AUSTRIAN ENERGY AGENCY

Comments on Energy Star Program Requirements for Computer Servers Draft 4

Fig: Power supply efficiency requirements in DRAFT 4 (smoothed curve between load points)

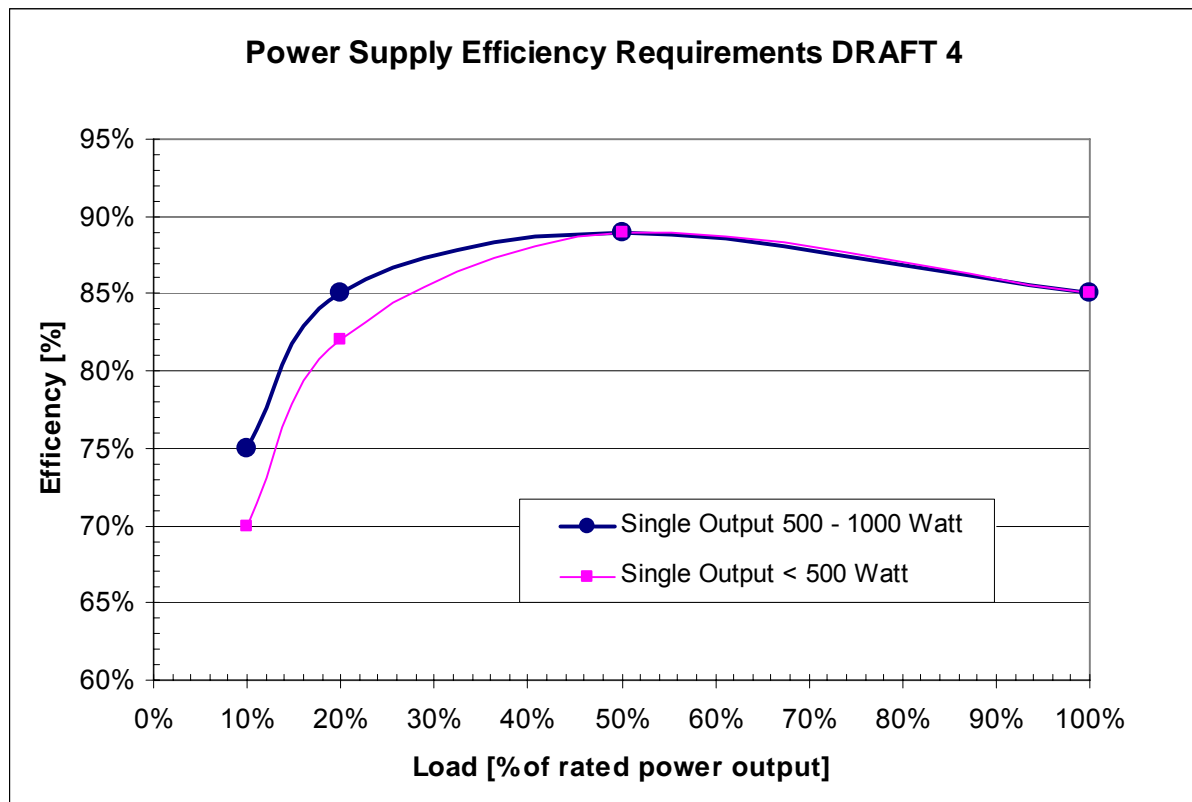
The allowance for an additional power supply seem to be rather generous. Thus there is a lack of incentive for appropriate dimensioning of power supplies. A rough evaluation based on the data in the “*Draft 4 Idle data set*” would support the recommendation to reduce this allowance to 10–15W depending on the specific idle level category to encourage the use of better sized power supplies. More details on this proposal can be found in the Annex.

Typical PSU load values were taken from the Idle power data set ¹ according to different idle levels of servers. In a next step a “typical” rated power for PSU were chosen for every category each. Based on the rated power of this representative power supplies and current efficiency requirements (values between defined points were interpolated via a smoothed curve, see Fig. above) numbers were picked for actual load points each. With these values for non redundant as well as redundant power supplies new On Idle values were derived for redundant PSU operation. The differences between the original (non redundant) and calculated (redundant) On Idle values are in the range of 7.6 – 13.3 Watt only (given the above mentioned assumptions).
